A/YL-SK/435

再次提議渠務報告 (Proposed)

事項: 回復 2026-02-26 信函 Comment

RE Proposed drainage plan

Drawing number : **b2-3**

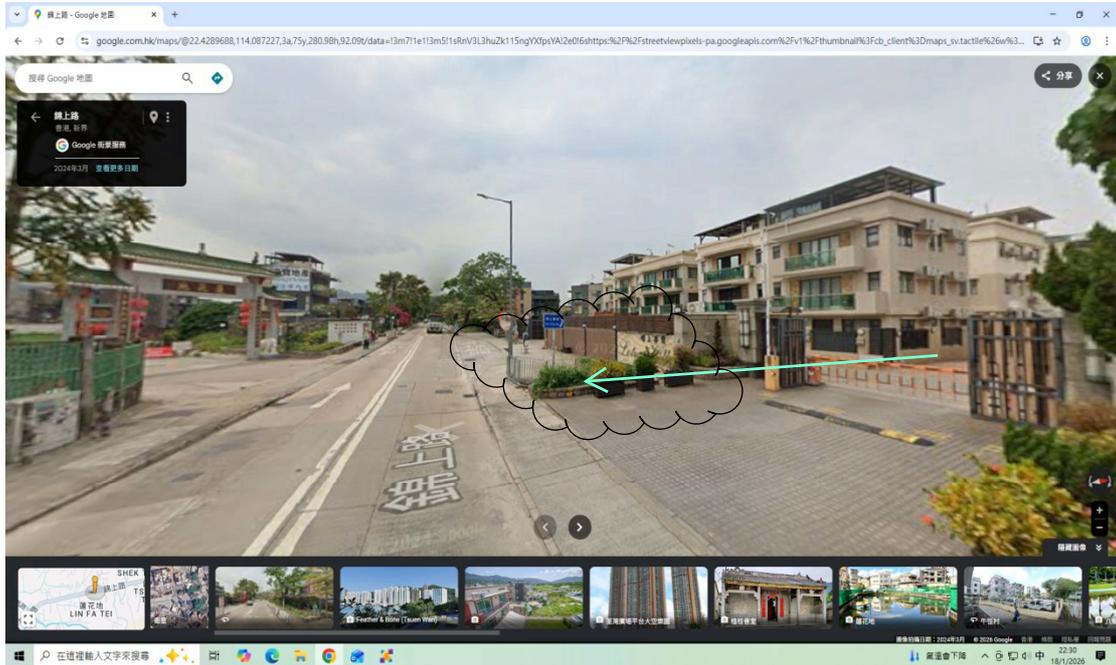
簡介	
2026-02-26 Comments	回復
i) Since the proposed drainage system from CP5 to CP99 will collect both the surface runoff from the application sites (A/YL-SK/435 and A/YL-SK/421) and the overland flow from adjacent site. Please consider upgrade the size and/or gradient of these proposed drainage facilities accordingly.	在b2-3 中已經修改 & e1-3 e2-3 e3-3中示
ii) Please review the gradient of the proposed 400mm u-channel (from CPI to CP25) is 1:25 or not. Please note that the hydraulic capacity of the downstream drainage facilities should not be smaller than the upstream ones. Please review.	在b2-3 中已經修改
iii) The submitted site photos cannot indicate and show the current conditions of the existing 600UC. Please provide more site photos at different views and locations for review.	因是私人地段和有高圍牆, 管理員不給予進入, 只能在出口有相片, 管理人員口頭說出要在政府有關官員作出申請進入, 其餘外來人士不得進入私人地方. (c3-3 & c4-3)
iv) The existing 600mm u-channel, to which the applicant proposed to discharge the stormwater from the subject site was not maintained by this office. The applicant(s) shall resolve any conflict/disagreement arisen for discharging the runoff from the application site(s) to the proposed discharge point(s). In the case that it is a local village drains, DO/YL should be consulted. Moreover, the applicant(s) should ensure that this drainage system and the existing downstream drains/channels/streams have adequate capacity to convey the additional runoff from the application site(s). Regular maintenance should be carried out by the applicant(s) to avoid blockage of the system.	知道和明白

v) The development should neither obstruct overland flow and nor adversely affect existing natural streams, village drains, ditches and the adjacent areas, etc.	知道和明白
vi) The applicant should resolve any conflict/disagreement with relevant lot owner(s) and seek permission from DLO/YL for laying new drains/channels and/or modifying/upgrading existing ones in other private lots or on Government Land, where required, outside the application site(s).	知道和明白

1. 回復信函內容 簡介 內示.
2.
 - a. 業權人提議的渠管道建造是由我司自費的.
 - b. 業權人提議的渠管道日後維修保養是我司的責任.
 - c. 業權人提議的渠管道, 也明白地權是政府/私人的.
 - d. 業權人承諾會得到政府部門同意/私人地段同意才會建設渠道工程.
 - e. 業權人聘任了 PERRY LEE BUILDING CONSULTANCY COMPANY 公司
作此次渠務顧問
